TSG-RAN WG1 meeting #15
Berlin, Germany
August 22nd – 25th, 2000

R1-001033

Agenda item: Release 2000 issues
Source: GBT
Title: GBT's response to Nokia's contribution: R1-00-890
Document for: Discussion (RAN WG1)

Agenda item: Release 2000 issues
Source: Nokia
Title: Remarks on the proposal for the improved cell RACH/FACH state
Document for: Discussion (RAN WG1), Information (RAN WG2)

Current Case: Total_C = 2x(lub + Tresp)

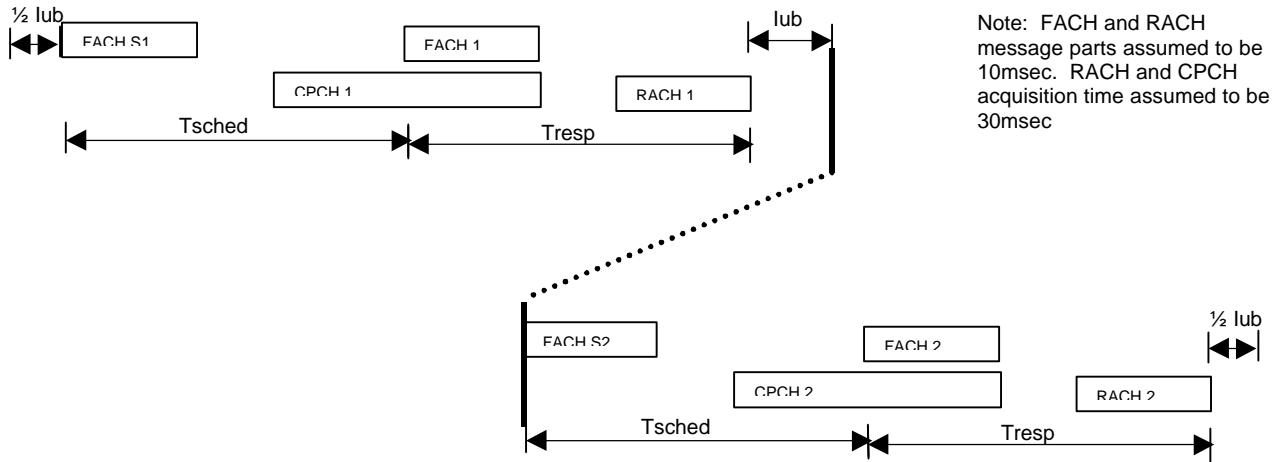
160 ms (assumed traffic equal to the FACH capability, + 160 ms advance scheduling to compensate the UE processing delay, RNC processing excluded)
160 ms (assumed traffic equal to the FACH capability, + 160 ms advance scheduling to compensate the UE processing delay) for scheduling of second retransmission
320 ms (1st FACH decoding, protocol processing, start up of CPCH TX+ procedure, 2nd FACH decoding, protocol processing, RACH or CPCH procedure for acknowledgement)
320 ms (retransmission procedure as above)
100 ms lub delay (roundtrip) for first TX
100 ms lub delay for second TX
+-----
Total of approximately 1200 ms

With the mentioned assumptions the QoS with proposed method is reduced due to the increased delay. Further if IP based transport is used on the lub, the delay jitters needs to be compensated with additional buffer for the proposed method since the scheduling message on FACH is tied to the particular SFN.

It seems as if this analysis double counts the scheduling delay with the transmission of the FACH scheduling message. As a result the 1200 ms delay value is not valid for this comparison. The correct value seems to be 840 msec under Nokia's assumptions. The below figures clarify and correct the above tabular analysis. However, under GBT's assumptions, the correct delay value is 460 ms.

In the above figures, FACH1 is the first transmission of the message, FACH2 is the retransmission of the same message, FACH Sn is the FACH scheduling message for CLPC of FACH n, which follows. RACH 1 is the RLC Nack to FACH1, while RACH 2 is the RLC Ack to FACH2.

Using this corrected analysis with the original delay assumptions: if lub = 100 msec and Tsched = Tresp = 160, then Total_C = 520msec, while Total_P = 840 msec (60% increase), NOT 1200 msec (130% increase) as suggested above.

FIGURE 1. CLPC FACH Timing.

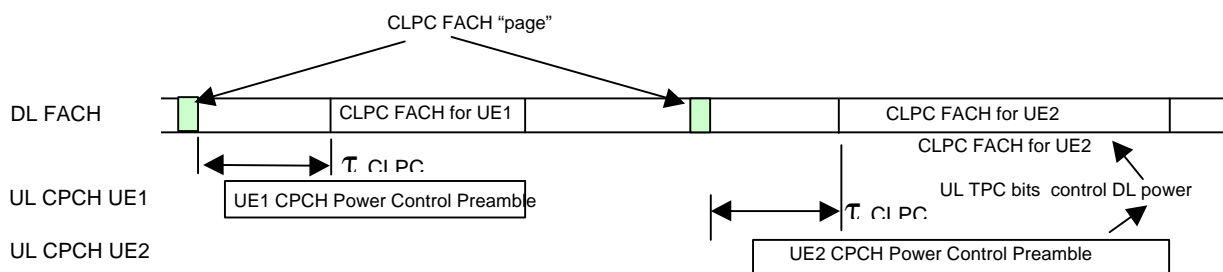
b) What is the minimum and max delay required between FACH "paging" and actual packet on the FACH? What does the calculated delay consist of (UE processing, CPCH procedure, Node B-RNC delay etc.)? Are CPCH procedure error events included?

(5) The scheduling delay, τ_{CLPC} , is deterministic and includes

$$\tau_{CLPC} = (N_{ap_retrans_max} + 1)\tau_{next_slot} + 5.28\text{msec},$$

Figure 1 below shows an overview of the CLPC FACH timing between the Node B and the UEs.

$$\tau_{CLPC} = (10 + 1) \times 3.75 + 5.28 \text{ msec} = 46.5 \text{ msec} \text{ (approximately 5 frames).}$$

$$\tau_{CLPC} = (5 + 1) \times 3.75 + 5.28 \text{ msec} = 27.8 \text{ msec} \text{ (approximately 3 frames).}$$
